**REQUEST FOR INFORMATION (RFI)**

<b>PROJECT :</b>	BKK2	<b>R.F.I. NO. :</b>	523213-01-RFI-ME-0008								
<b>TO :</b>	CTA	<b>ATTENTION :</b>	CTA								
<b>SUBMITTED DATE</b>	12-Jan-26	<b>NEED REPLY BY DATE :</b>	19-Jan-26								
<b>SUBMISSION OF :</b> <input checked="" type="checkbox"/> Q&A <input checked="" type="checkbox"/> Drawing <input type="checkbox"/> Document <input type="checkbox"/> Others (as specified below)											
<b>SUBJECT :</b> Request for Confirmation - Add Isolation Valve and Check Valve for DRG-ME-0103, 0104 and 0105											
<b>Total Page (s) :</b> 4 (Including this page)											
<b>FUNCTION :</b> <table border="0"> <tr> <td><input type="checkbox"/> Structural (ST)</td> <td><input type="checkbox"/> Electrical &amp; Communication (EL)</td> <td><input checked="" type="checkbox"/> Mechanical (ME)</td> <td><input type="checkbox"/> Vertical Transport (VT)</td> </tr> <tr> <td><input type="checkbox"/> Architectural (AR)</td> <td><input type="checkbox"/> Fire Protection (FI)</td> <td><input type="checkbox"/> Hydraulic &amp; Sanitary (HY)</td> <td><input type="checkbox"/> Other (O)</td> </tr> </table>				<input type="checkbox"/> Structural (ST)	<input type="ch

523213 - 02 - DRG - ME-0103

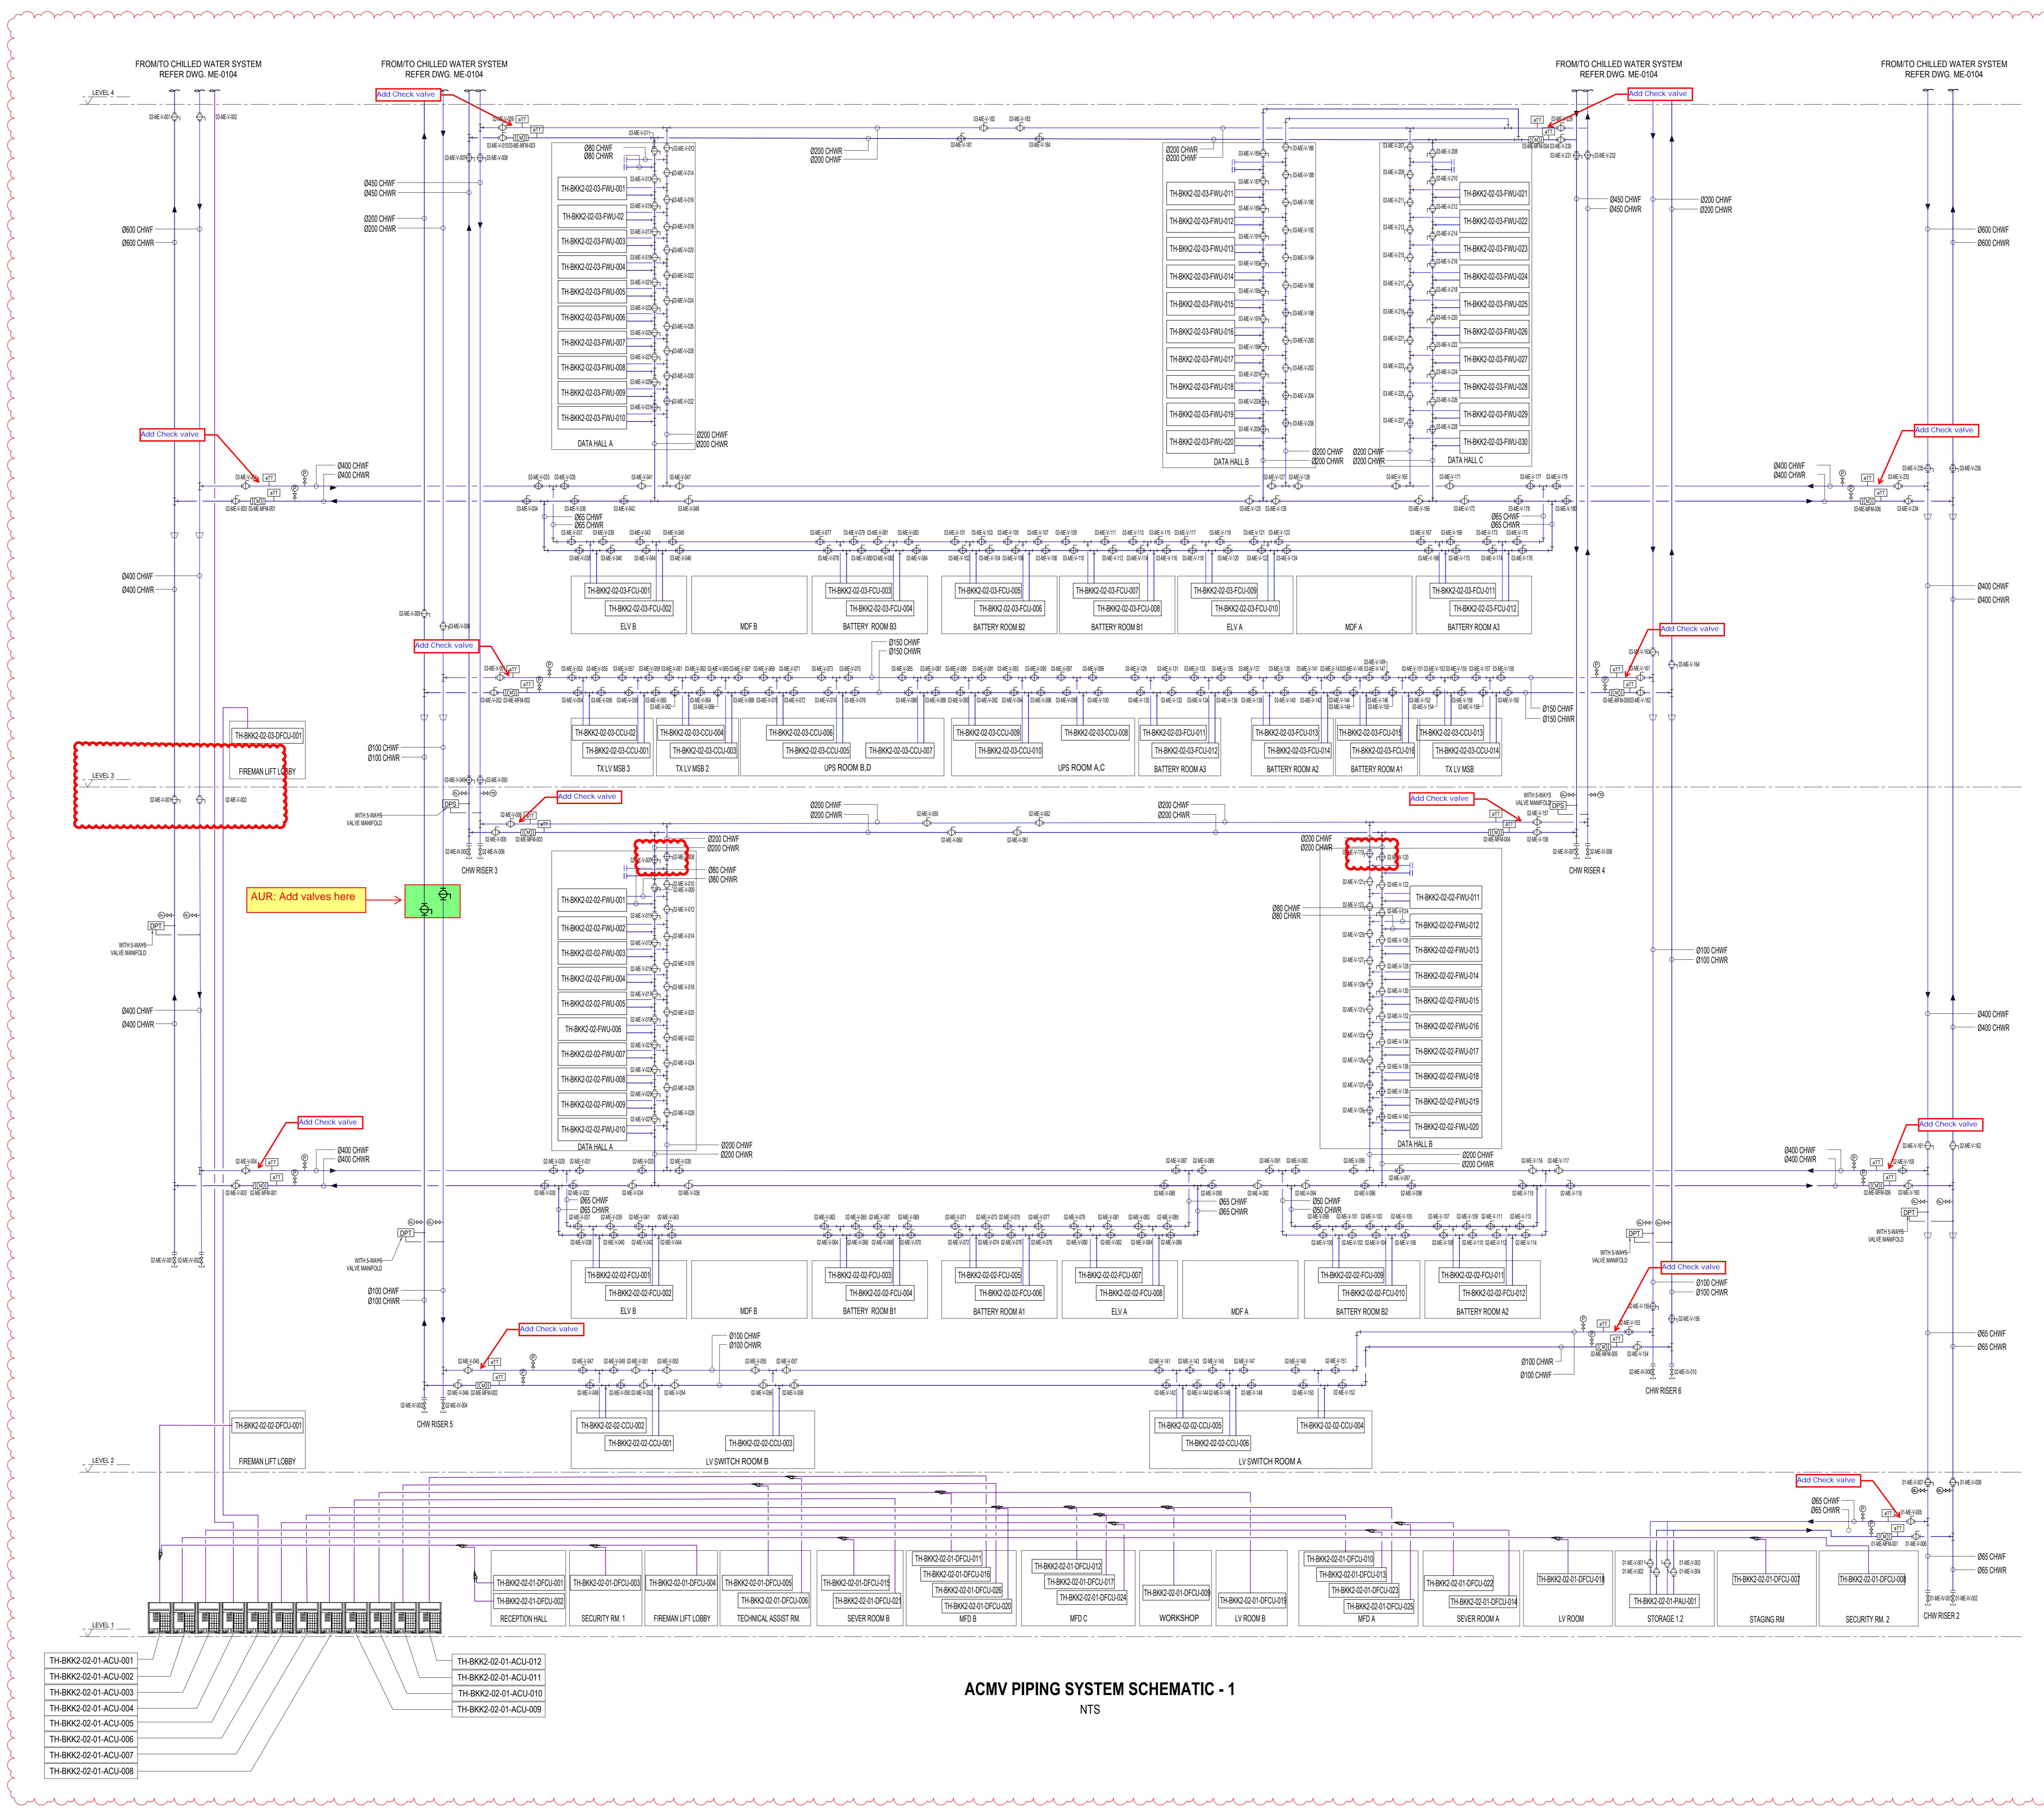
2)With reference to DWG No. 523213-02-DRG-ME-0103,0104, a check valve on the CHWF pipes is proposed to be added at each branch from the riser for commissioning purposes.

**AUR: Please canceled all the purposed check valves and isolation valves by contractor because the system can still maintain concurrently maintainable without the purposed valves**

Note : 1. Please canceled all the purposed check valves and isolation valves by contractor because the system can still maintain concurrently maintainable without the purposed valves  
2. Please add the valves purposed by Aurecon in Green Highlighted only
